RE: PPA Case No. 2014.1041U for 390 1st Street

Preliminary Project Assessment

Date:	October 6, 2014
Case No.:	**2014.1041U**
Project Address:	390 1st Street
Block/Lot:	3749/058
Zoning:	RH-DTR (Rincon Hill Downtown Residential) 65/400-R & 45/65-R
Project Sponsor:	Mill Creek Residential Trust, LLC 1810 Gateway Drive, Suite 240 San Mateo, CA 94404 (650) 293-3574
Staff Contact:	Doug Vu – (415) 575-9120 Doug.Vu@sfgov.org

Title: 390 1st Street Preliminary Shadow Fan
Printed: 5 August, 2014

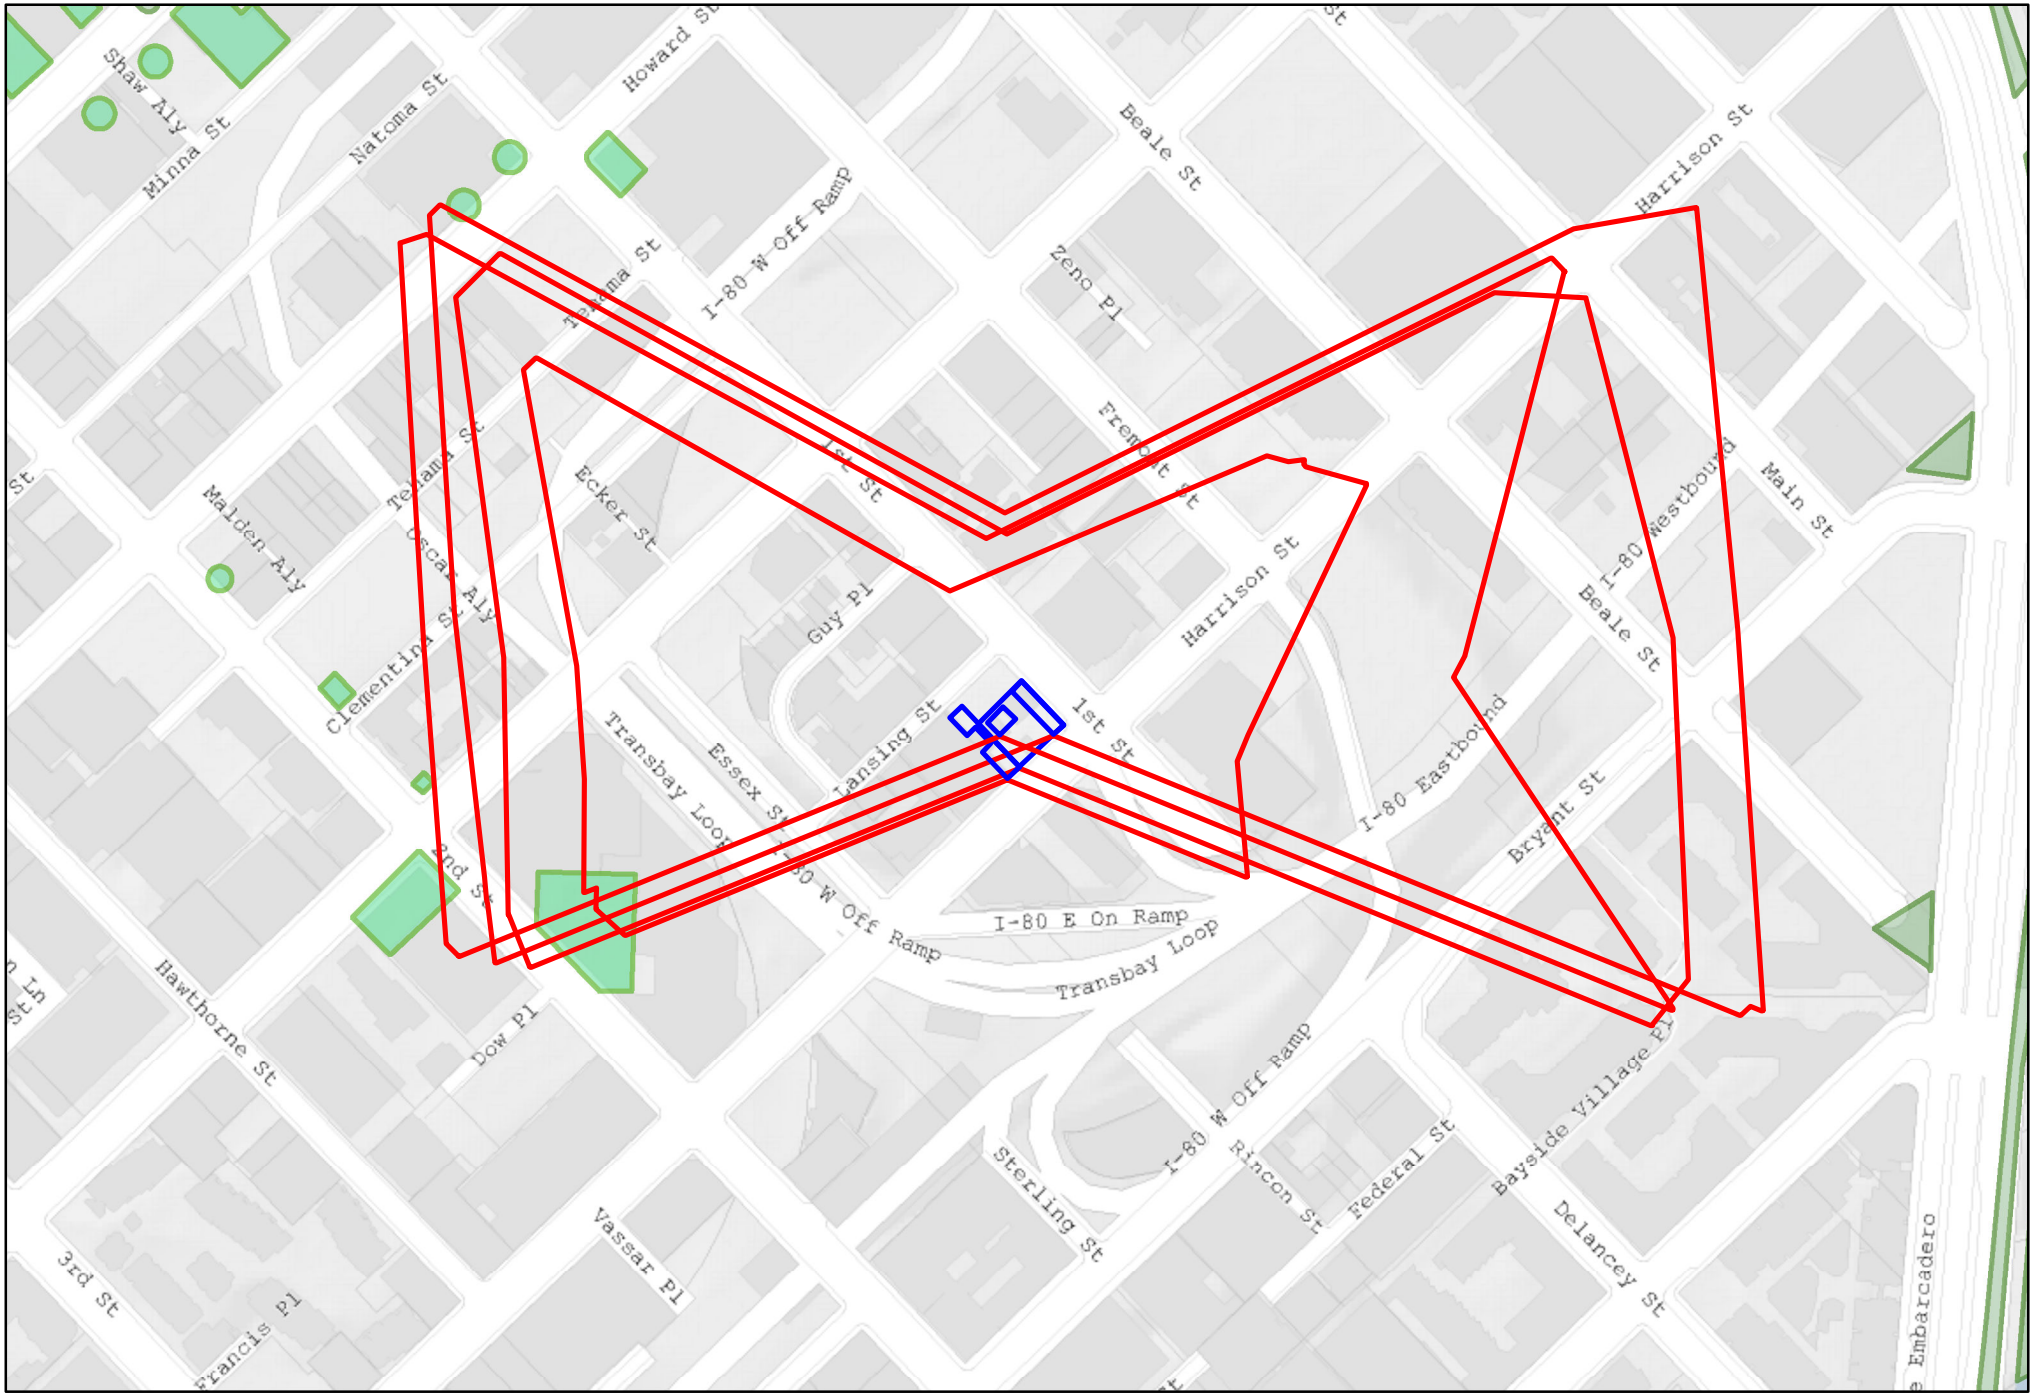
8. **Shadow Study.** The proposed project would result in construction of a building approximately 130 feet in height. A preliminary shadow fan analysis has been prepared by Planning Department staff, which indicates that the proposed project could cast shadows on several privately-owned public open spaces (see attached). The project sponsor, therefore, would be required to prepare a shadow study, which would have to be conducted by qualified consultant. The consultant would be required to submit a Shadow Study Application.[7] A separate fee would be required with the Shadow Study Application. Furthermore, the consultant would be instructed to prepare a proposed scope of work for review and approval by the Environmental Planning case manager prior to preparing the analysis.
